### **REMARKS**

**Applicant:** Lee et al.  
**Application No.:** 10/617,335

Fig. 4

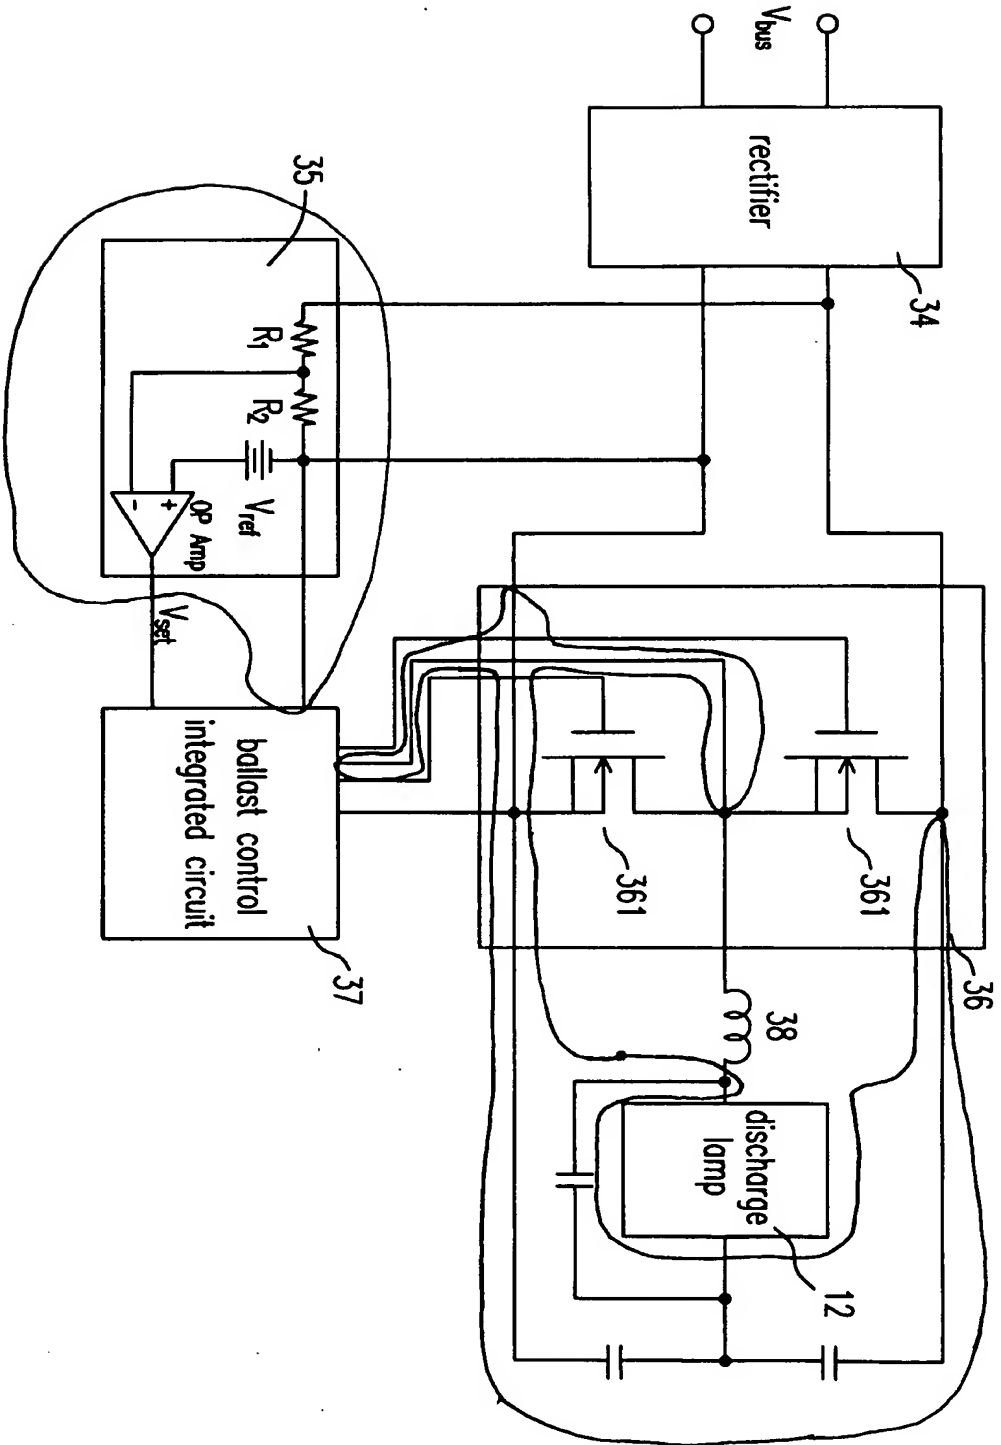
The esteemed examiner considered that the 'operational amplifier' recited in line 2 of Claim 7 must be shown. The Fig. 4 is modified according to the esteemed examiner's opinions etc. as described above.

In Fig. 4, the voltage converter 35 is modified to show that the voltage converter 35 includes an operational amplifier and other elements as disclosed in the amended claim 7 according to the esteemed Examiner's opinion. Further, extra connecting circuits among voltage converter 35, the inverter 36, the ballast control integrated circuit, and the discharge lamp 12 are modified and three capacitors (one for the resonant LC circuit and two for the half-bridge circuit, which all are elements of the ballast circuit known in the prior art) are added in Fig. 4 so as to show the configuration of the proposed dimming control system in more detail such that the unique features of the present invention can be fully understood.
